DART AEROSPACE LTD	Work Order:	119711
Description: Crosstube Assembly (205/212 High Aft)	Part Number:	D212-664-241
Inspection Dwg: D212-664-241 Rev: D		Page 1 of 2

DRAWING NO. D212-664-241	TITLE CROSSTUBE ASSY (205/212 HI AFT)	REV. D	DART AEROSPACE LTD ENGINEERING ORDER		D.E.O. NO. D212-664-241-D-1	SHEET NO. SHEET 1 OF 2	SCALE NTS
DRAWN	CHECKED	MFG. APPR.	APPROVED	DE APPR.			
DATE 11.04.07	DATE 11.04.11	DATE 11.04.12	DATE 11/04/12	DATE 11.04.12

ADD AN INSPECTION WINDOW TO UNDERSIDE OF CROSSTUBE.

DRAWING NO. D212-664-241	TITLE CROSSTUBE ASS'Y (205/212 HI AFT)	REV. D	DART AEROSPACE LTD ENGINEERING ORDER		D.E.O. NO. D212-664-241-D-2	SHEET NO. SHEET 1 OF 1	SCALE NTS
DRAWN <i>q</i>	CHECKED <i>ASS</i>	MFG. APPR. <i>DS</i>	APPROVED <i>MD</i>		DE APPR. <i>MD</i>		
DATE 11.07.15	DATE 11.07.20	DATE 11.07.21	DATE 11.07.21		DATE 11.07.21

**D212-664-241/-241B
ASSEMBLY DETAIL**

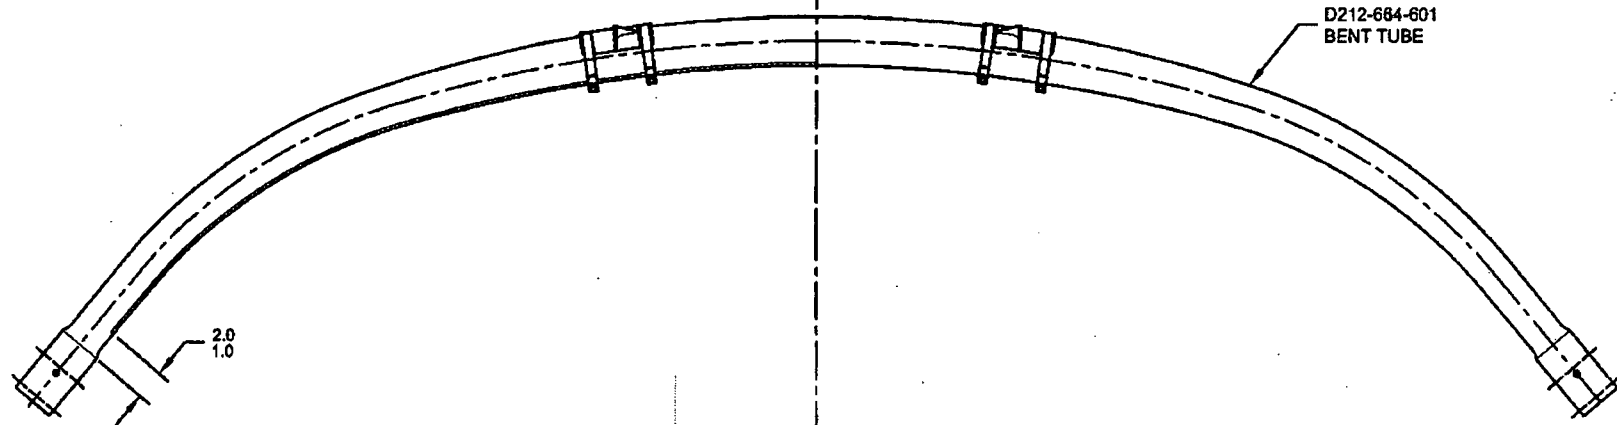
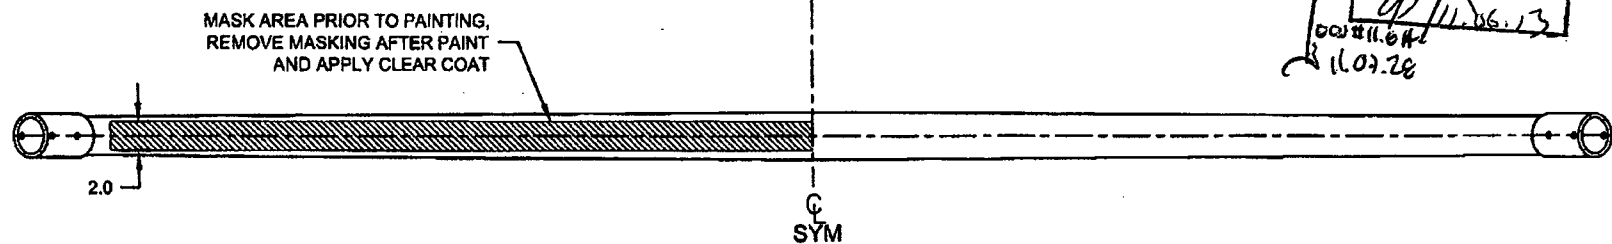
NOTES 2 OF SHEET 1 IS AMENDED AS FOLLOWS:

- 2) FINISH: CHEMICAL CONVERSION COAT PER DART QSI 005 4.1
PRIME INSIDE AND OUTSIDE PER DART QSI 005 4.2
MASK UNDERSIDE OF CROSSTUBE AS SHOWN (HATCHED AREA) AND
PAINT OUTSIDE PER DART QSI 005 4.2
REMOVE MASKING AND APPLY CLEAR COAT

- 2) FINISH: CHEMICAL CONVERSION COAT PER DART QSI 005 4.1
PRIME INSIDE AND OUTSIDE PER DART QSI 005 4.2
PAINT OUTSIDE PER DART QSI 005 4.2
